DESIGN CHANGE FOR DEFLECTION PULLEY 55941

TECHNICAL INFO No. 1039

Citroen	Berlingo, Jumpy, Xsara
Fiat	Scudo
Peugeot	206, 306, Expert, Partner

1.9 D

Deflection pulley 55941, previous design (A) and new design (B)

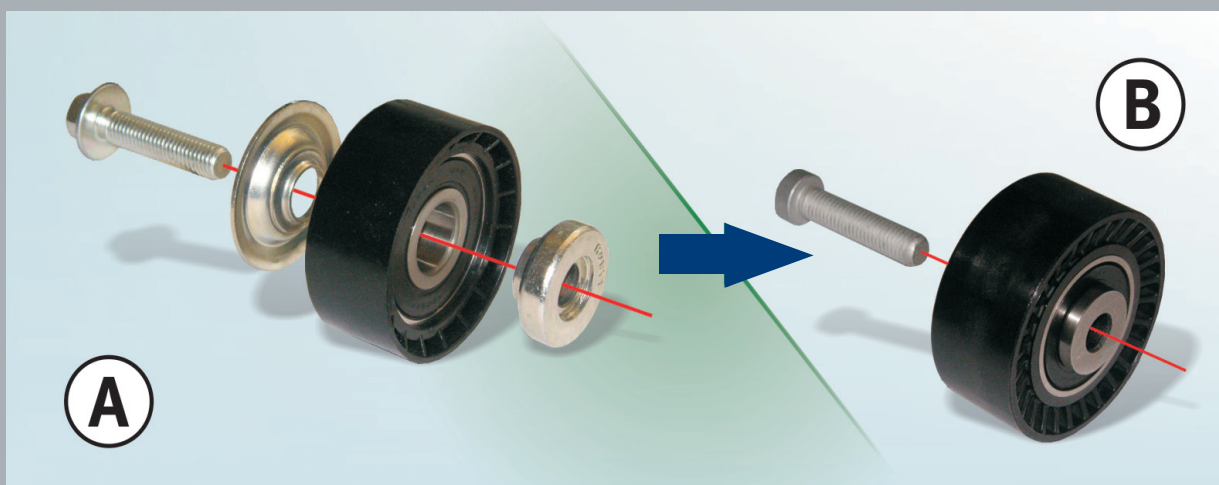
The deflection pulleys under A and B (see image) must only be mounted using the bolt provided.

Pulley A: M10x45, hex. bolt with collar

Pulley B: M10x45, Torx bolt

The design of deflection pulley 55760 has been modified as part of our efforts to continuously develop our products. In the new design, the plate and spacer (A) are no longer delivered as individual items as was previously the case. These components have been integrated in the new variant (B) and are now an integral part of the deflection pulley. During the transition period, we may have mixed stocks of both types. Both versions meet the relevant technical specifications and can be used without restrictions.
